Agenda Item # 11

SUB-003823-2026

Chamberlain – Old Shell Subdivision

- Subdivision approval to create three (3) legal lots of record from three (3) metes-and-bounds parcels.

DETAIL SITE PLAN

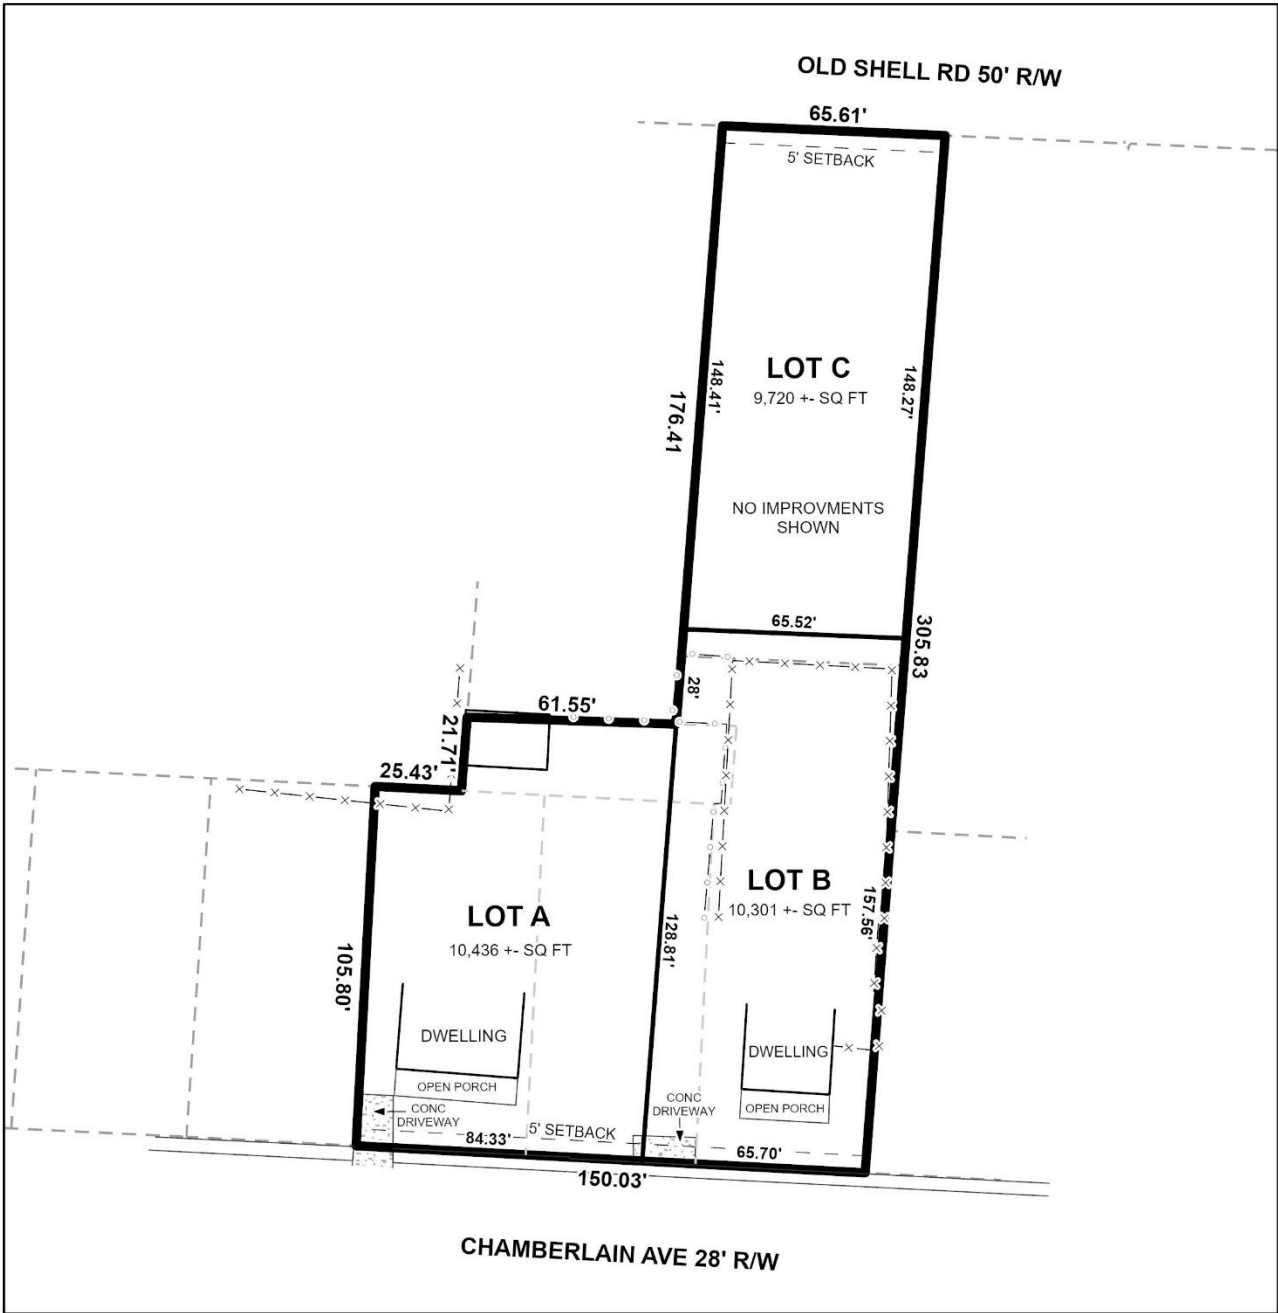
- B. Label the POB.
- C. Revise NOTES #7 to read "As shown on the aerial photos LOTS A and B will share the 50,100 sf of historical credit of existing impervious area towards stormwater detention requirement per Mobile City Code, Chapter 17, Storm Water Management and Flood Control) and share the 8,000 SF credit provided to the original SF residential lot as follows: LOT A – 9,000 sf, and LOT 2 – 6,300 sf. Stormwater detention will be required for any additional impervious area that exceeds the allowable credit for that LOT.

The proposed lots have frontage along Old Shell Road and Chamberlain Avenue, both of which are minor streets with curb and gutter requiring a 50-foot-wide right-of-way. The preliminary plat depicts sufficient right-of-way along Old Shell Road; however, only 28 feet of right-of-way is depicted along Chamberlain Avenue. Therefore, additional right-of-way along Chamberlain Avenue will be required to provide the full 50-foot width, unless a waiver of Section 6.B.9 of the Subdivision Regulations is obtained. If approved, this information should be reflected on the Final Plat.

A five (5)-foot front yard setback is depicted along each street frontage; however, the lots are located within the Old Dauphin Way Historic District Overlay (HDO), where front yard setbacks are required to be consistent with those structures located on the same side of the street within 150 feet of the proposed building site, measured in both directions and exclusive of right-of-way. Because front yard setbacks within the HDO are determined by the surrounding development, the five (5)- foot front yard setbacks should be removed and a note should be placed on the Final Plat stating that development of the site shall comply with the provisions of Article 14 of the Unified Development Code, including the front yard dimensional standards applicable within the Historic District overlay.

1. Retention of the 50-foot-wide right-of-way along Old Shell Road;
2. Revision of the Final Plat to depict dedication sufficient for a 50-foot-wide right-of-way along Chamberlain Avenue or a waiver of Section 6.B.9 of the Subdivision Regulations;

3. Retention of the lot sizes in square feet and acres on the Final Plat, adjusted for any required dedication;
4. Revision of the Final Plat to remove the five (5)-foot front yard setbacks and to add a note stating that development of the site shall comply with the provisions of Article 14 of the Unified Development Code, including the front yard dimensional standards applicable within the Historic District overlay;
